Access Compliance Report

Public Rights-of-Way

(Curb Ramps)

Intersection ID: 4428	Main Street: LONG_CREEK_PARK_DR	Cross Street: STATESVILLE_RD	Location: SE
ADA ID: EDF4455D31A9	Ramp Type: BlendTrans2	Initial Pass/Fail: Fail	Overall Compliance: No
Severity Score: 1.25			
Codes/Mitigation Info/Possible Solution		Field Measurements/Component Compliance

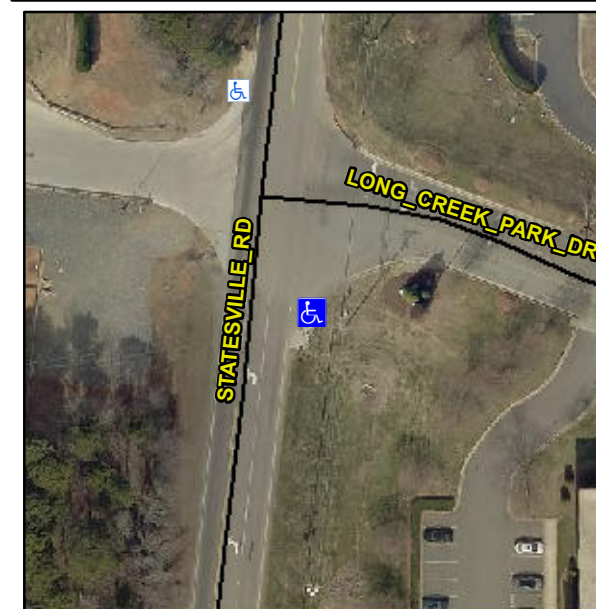
NO CURB

R304.5.3

Compliance	Description	Data	Compliance	Description	Data
N/A	Ramp Length (in)	64.0	Yes	BlendTrans Slope (%)	0.1
Yes	Ramp Width (in)	96.0	No	BlendTrans XSlope (%)	2.1
N/A	Flare Type LT	None	N/A	Flare Type RT	None
N/A	Flare Slope LT (%)	N/A	N/A	Flare Slope RT (%)	N/A
N/A	Flare Traversable LT?	N/A	N/A	Flare Traversable RT?	N/A
N/A	Landing Length (in)	N/A	N/A	DWS Provided?	Yes
N/A	Landing Width (in)	N/A	N/A	DWS Contrast?	Yes
N/A	Landing Slope (%)	N/A	N/A	DWS Length (in)	24.0
N/A	Landing X Slope (%)	N/A	N/A	DWS Full Width?	No
N/A	Landing Curb? (Y/N)	No	N/A	DWS Offset (in)	6.5
N/A	Shared Landing?	No			
N/A	Gutter Ponding?	No	N/A	Gutter Slope (%)	2.6
N/A	Gutter Lip Ht (in)	0.0	N/A	Gutter X Slope (%)	2.5
N/A	Painted X Walk1?	No	N/A	Painted X Walk2?	N/A
	X Walk 1 Direction	To NW		X Walk 2 Direction	N/A
	X Walk 1 Width (in)	N/A		X Walk 2 Width (in)	N/A
	X Walk 1 Slope (%)	2.5		X Walk 2 Slope (%)	N/A
	X Walk 1 X Slope (%)	2.3		X Walk 2 X Slope (%)	N/A

Remove & Replace Curb Ramp With Two New Directional Ramps or Equivalent.
